Subject: Detroit Edison Company Response to NRC Request for Additional Information 02.05.02-15

**Response to RAI Letter No. 36
(eRAI Tracking No. 4766)**

RAI Question No. 02.05.02-15

Figure 1 - Mean Hazard Curves for the Dames & Moore Team Sources Computed Using Subset of EPRI (2004, 2006) Ground Motion Models

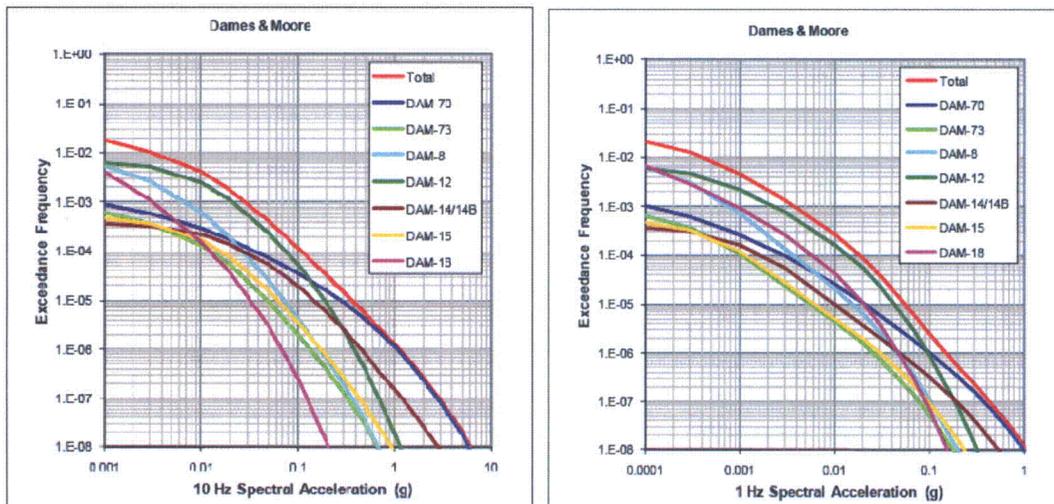
In response to RAI 02.05.02-8, you indicated that, based on the occurrence of two post-EPRI/SOG earthquakes of mb 5.0 and 5.2, the probability of activity for the Dames and Moore source zone DAM08 increased from 0.08 to 1 in the Fermi 3 PSHA. Therefore, please explain why the hazard contribution from the source zone DAM08 appears to be so low in comparison to other sources included in FSAR Figure 2.5.2-223. In addition, please demonstrate your ability to back calculate rock hazard curves for source zone DAM08 (shown in FSAR Figure 2.5.2-223) using the GMRS hazard curves shown in Figure 10 of your response to RAI 02.05.02-8 by factoring in corresponding amplification factors. This request is in accordance with 10 CFR 100.23.

The mean seismic hazard curve for Dames & Moore Source 8 shown on FSAR Figure 2.5.2-223 was calculated with the original probability of activity of 0.08. As described in the response to RAI 02.05.02-8 in Detroit Edison letter NRC3-10-0012 (ML100540502), dated February 15, 2010, the probability of activity of this source was revised up to 1.0 for the updated seismic hazard analysis conducted for Fermi 3. Figure 1 shows the mean hazard for Dames & Moore Source 8 computed using the probability of activity of 1.0 used in the updated seismic hazard model for the Fermi 3 site. In addition, the hazard curve for the Dames & Moore source related to the Wabash Valley (Source 18, Southern Illinois/Southern Indiana) is added to make Figure 1 consistent with the FSAR text and Table 2.5.2-202. The total hazard curve is also adjusted to show the sum of the source hazard curves shown on the plot. FSAR Figure 2.5.2-223 will be replaced with Figure 1.

~~Figure 2.5.2-222~~

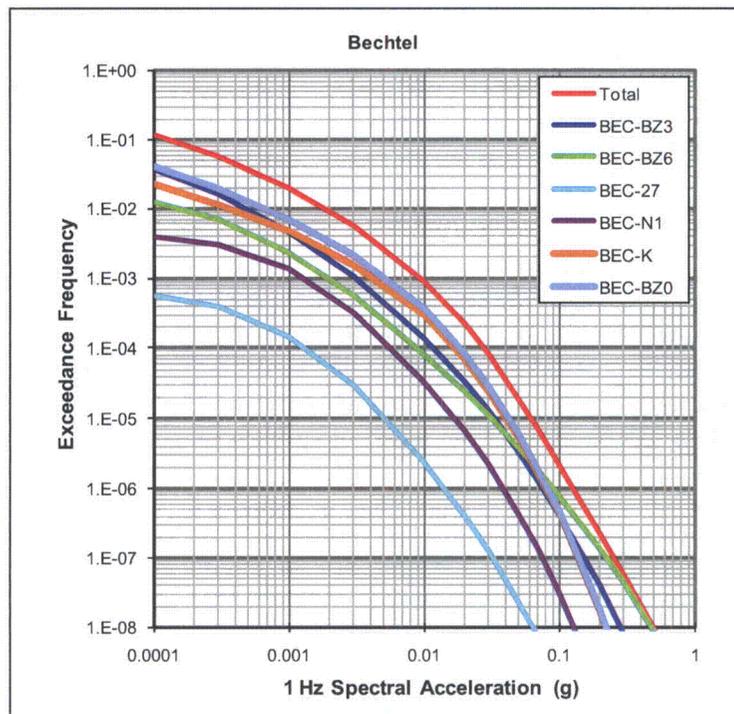
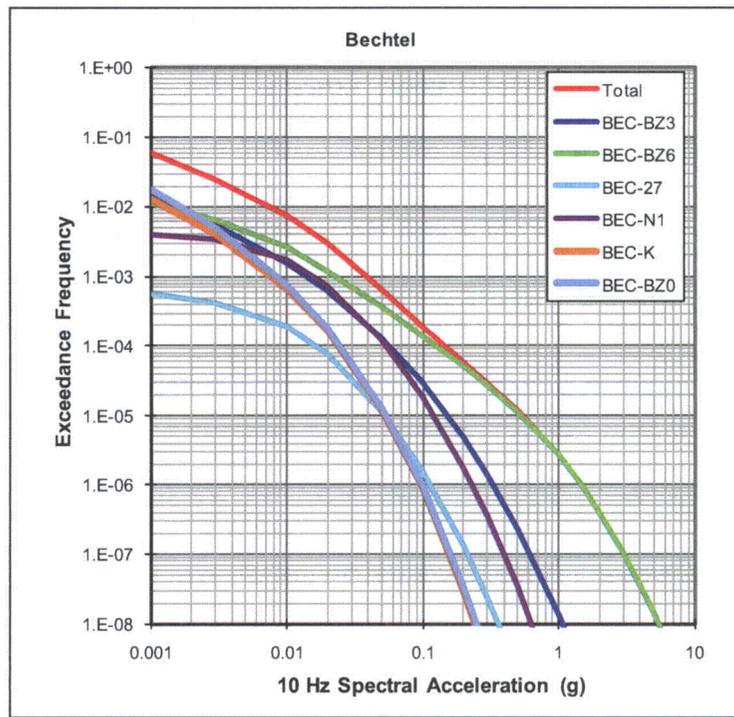
In order to make FSAR Figures 2.5.2-222, 2.5.2-224, 2.5.2-225, 2.5.2-226, and 2.5.2-227 consistent with Tables 2.5.2-201, 2.5.2-203, 2.5.2-204, 2.5.2-205, and 2.5.2-206, respectively, and the FSAR text, mean hazard curves for the individual EPRI-SOG earth science team's seismic sources related to the Wabash Valley region are added to the respective figures. The additions are:

- Hazard curves for Bechtel sources K and BZ0 are added to FSAR Figure 2.5.2-222
- A hazard curve for Law source 7 is added to FSAR Figure 2.5.2-224
- Hazard curves for Rondout sources 2 and 4 are added to FSAR Figure 2.5.2-225
- A hazard curve for Weston Geophysics source 33 is added to FSAR Figure 2.5.2-226
- Hazard curves for Woodward-Clyde sources 43 and 44 are added to FSAR Figure 2.5.2-227

In all of these figures, the total hazard curve is adjusted to show the sum of the source hazard curves presented on each figure and listed in the corresponding table in the FSAR (Tables 2.5.2-201 through 2.5.2-206).

Figure 2.5.2-228 Effect of Update of EPRI-SOG and Additional Sources on the Seismic Hazard for the Fermi 3 Site. Hazard computed using Subset of EPRI (2004, 2006) Ground Motion Models

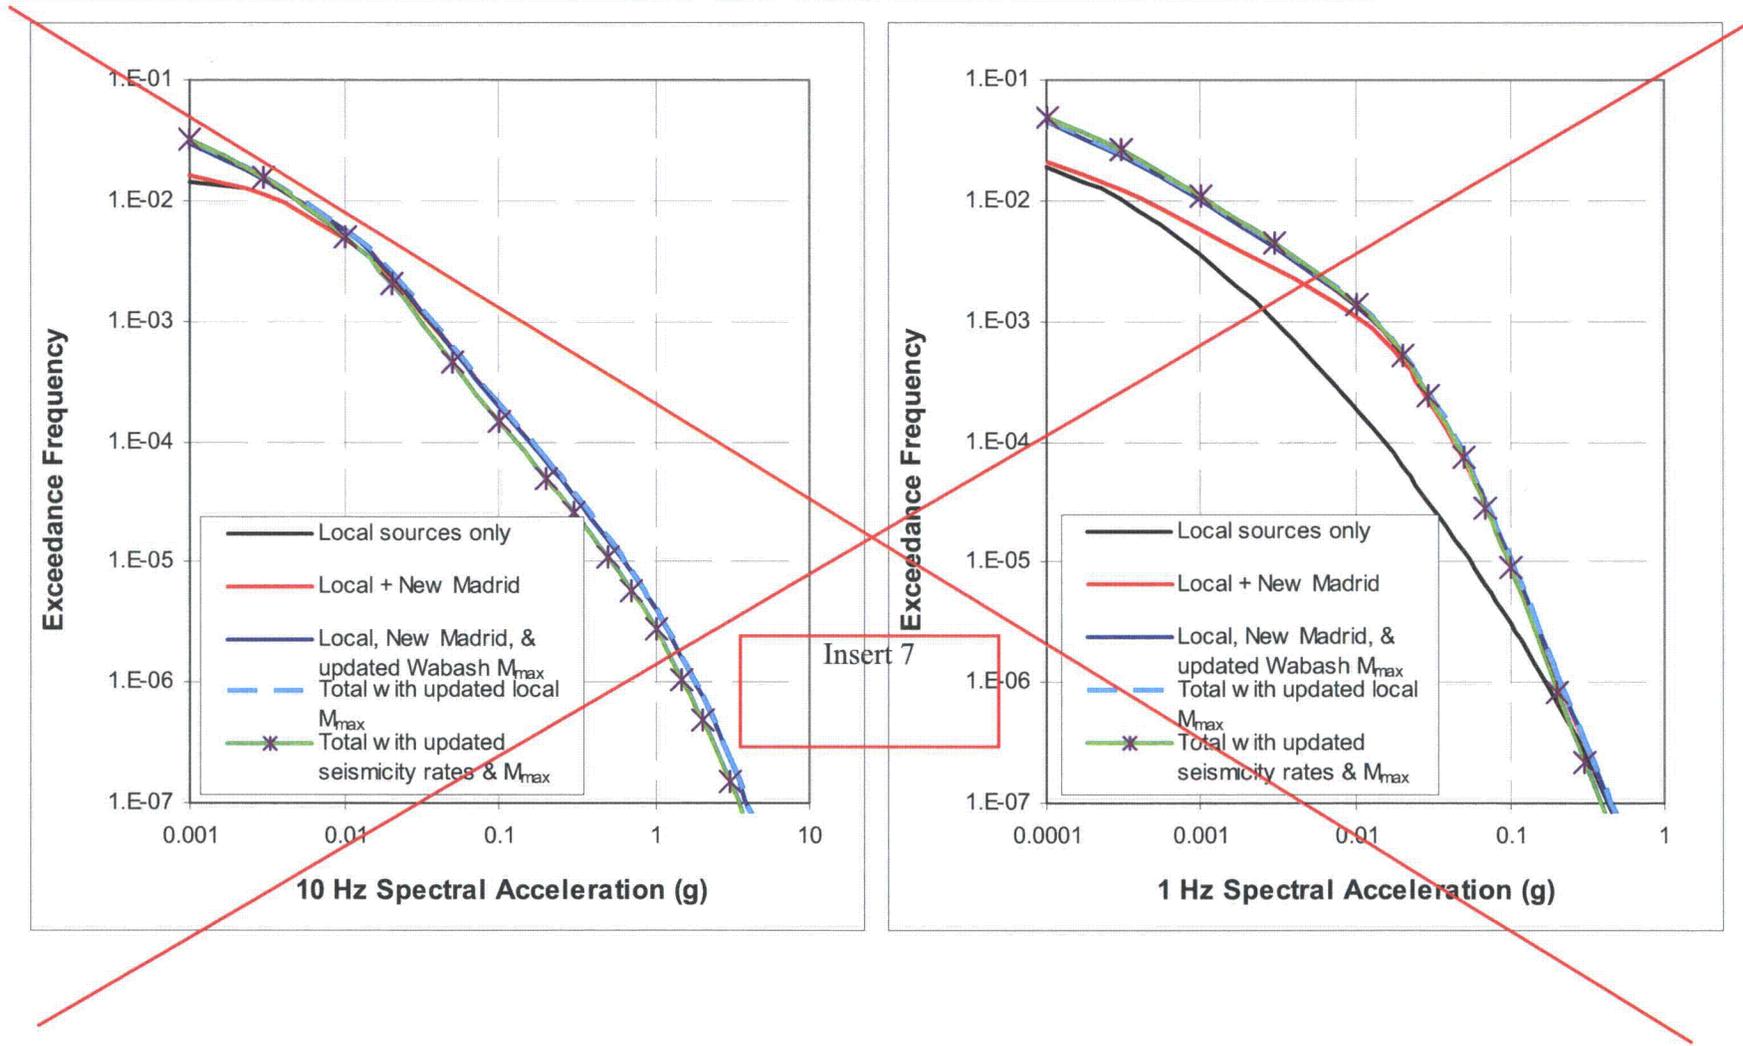
obtained using either the subset or full ground motion models for the Dames & Moore Team sources show that the sources not included in FSAR Table 2.5.2-202 contribute less than one percent to the Fermi 3 site hazard. A note will be added to the captions of FSAR Figures 2.5.2-222 through 2.5.2-228 to indicate the results are for a subset of ground motion models.
